CITY OF ALBUQUERQUE

**Re: Lot 39 Block 5 Volcano Cliffs Unit 5
8020 Monte Carlo Dr. NW
Grading & Drainage Plan Dated: 2/28/2021
Pad Certification dated: 4/22/2021 (E10D101)**

Lots 39, Block 5, Volcano Cliffs Subdivision, Unit 5
8020 monte Carlo Dr., NW
GRADING PLAN

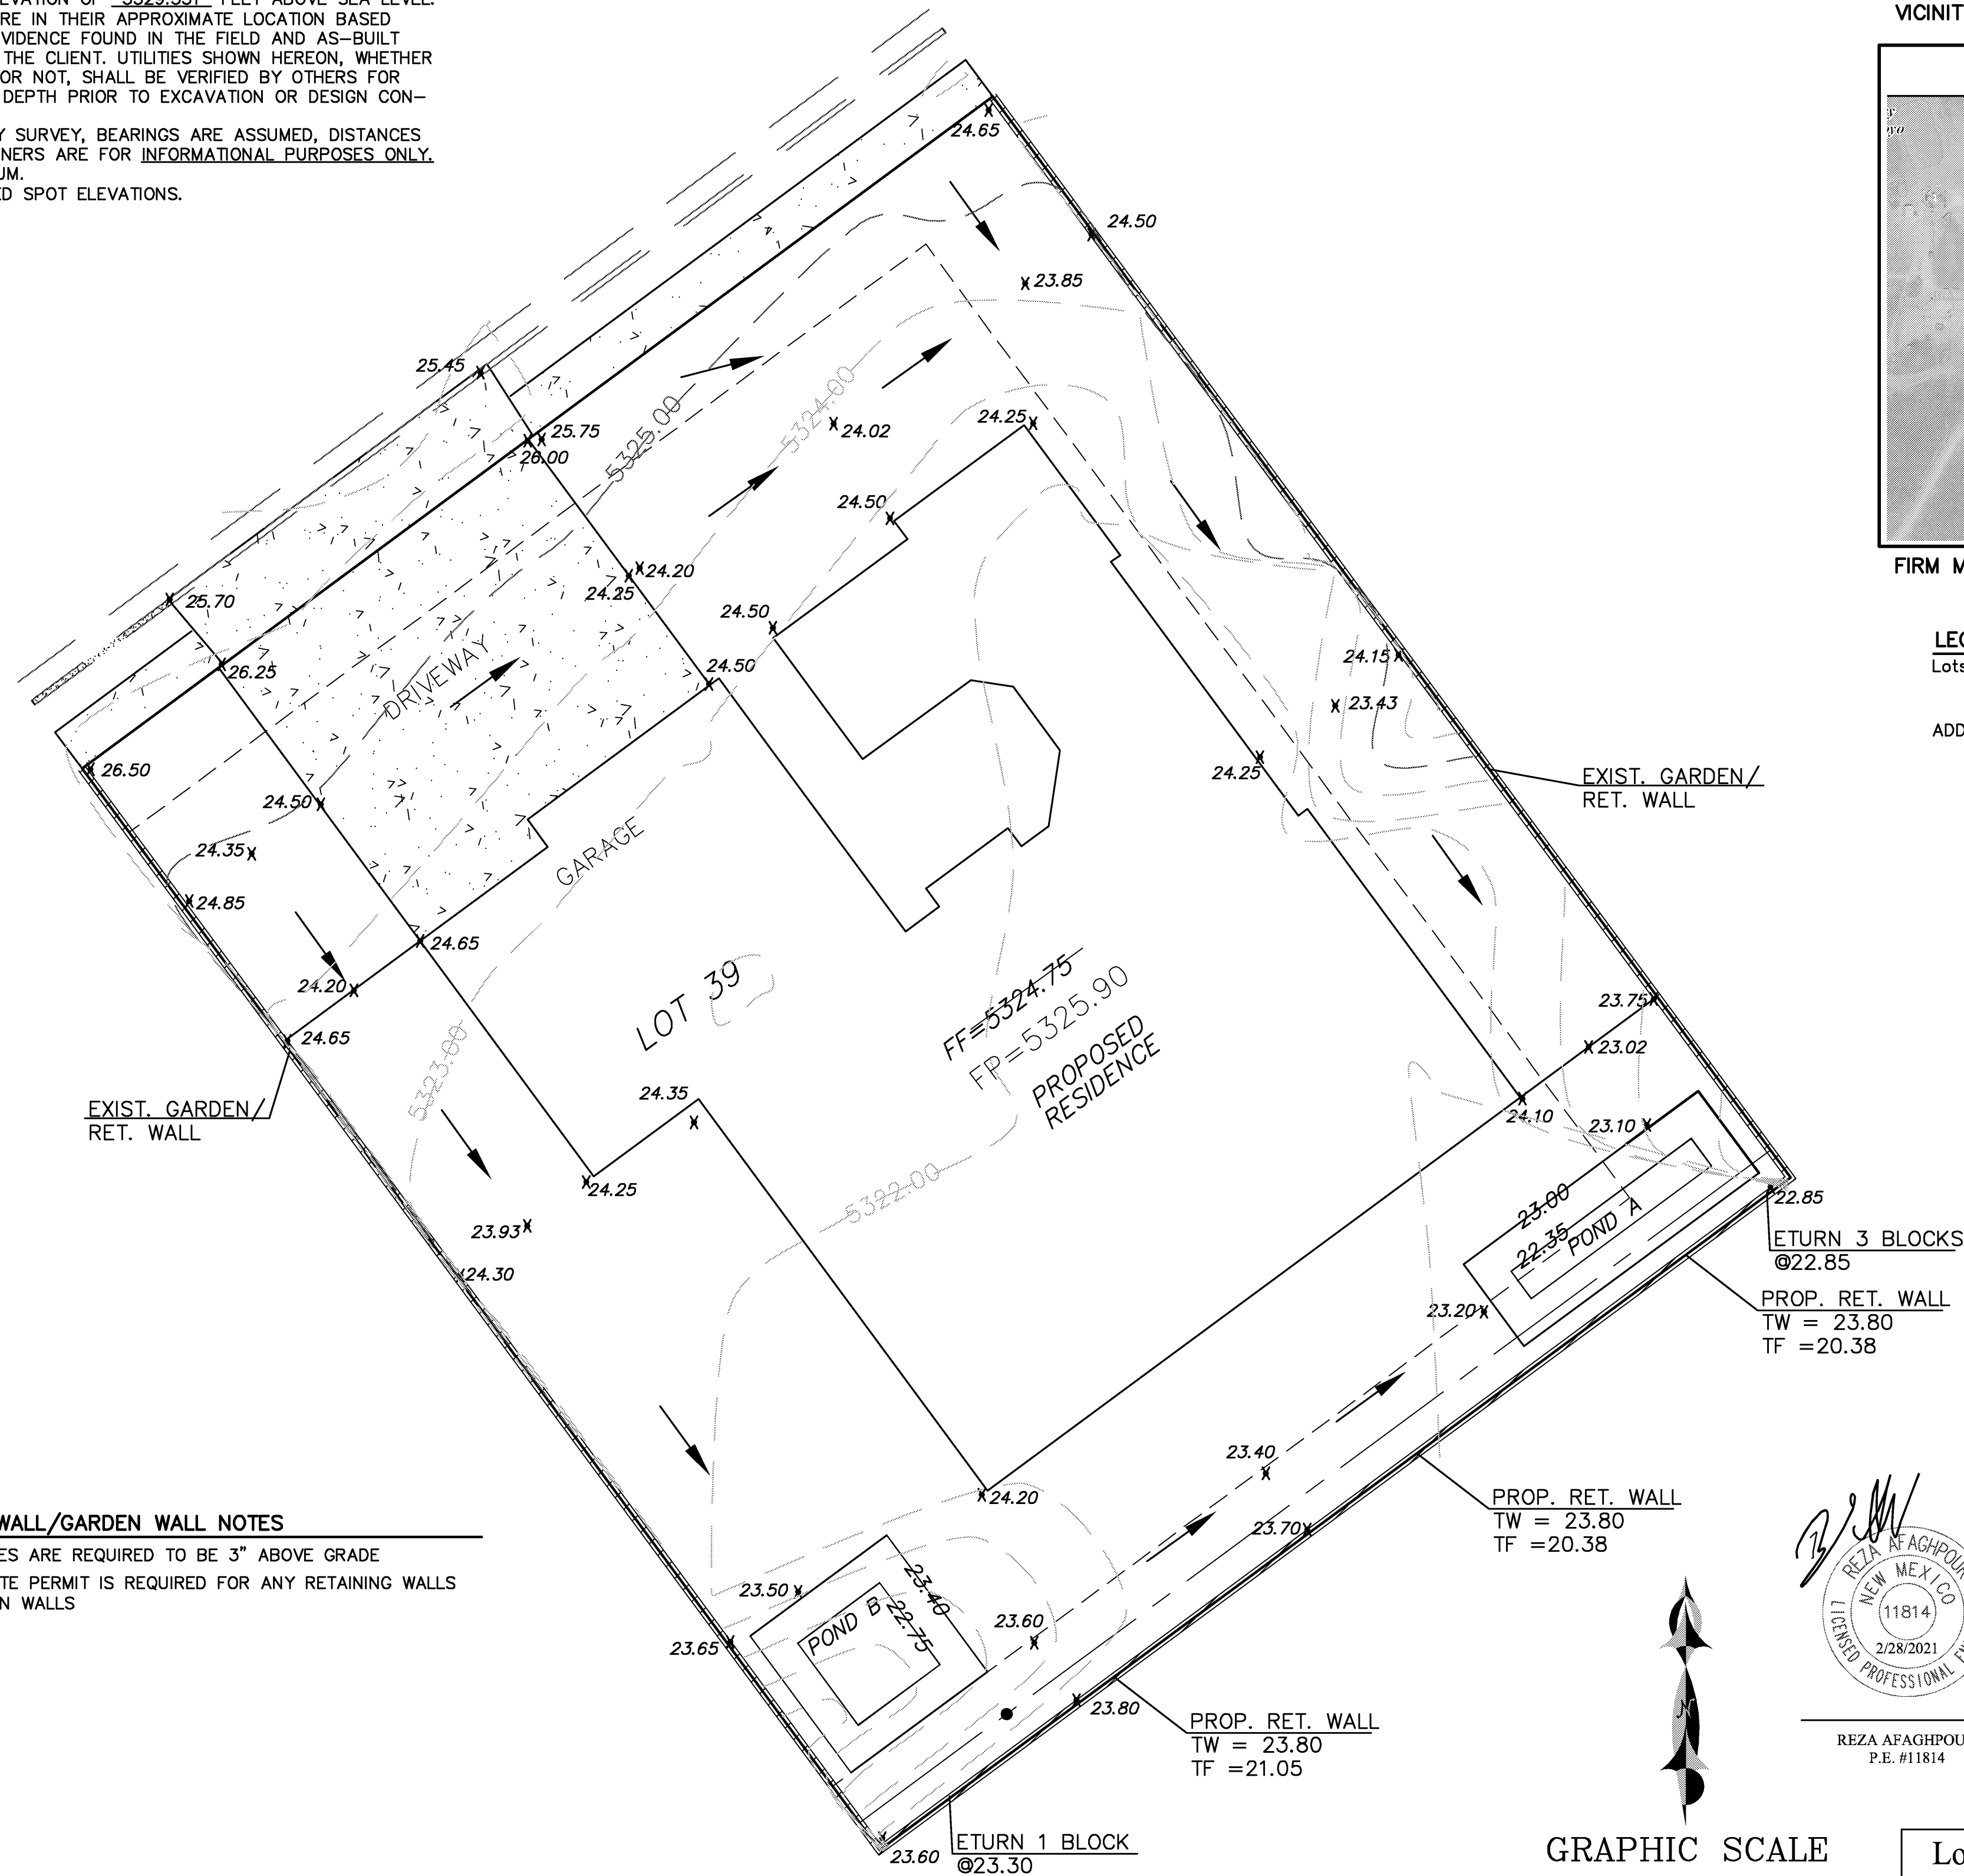
Based upon the information provided in your submittal received 4/26/2021, this plan is approved for Building Permit. **Inform the owner/contractor not to use dirt as a ramp to climb the curb, wood or millings may be used for this operation.**

Reiterate to the Owner/Contractor that a separate permit for a garden/retaining wall must be obtained, with the approved G&D plan dated 2/28/2021.

Prior to Certificate of Occupancy release, Engineer Certification per the DPM checklist will be required.
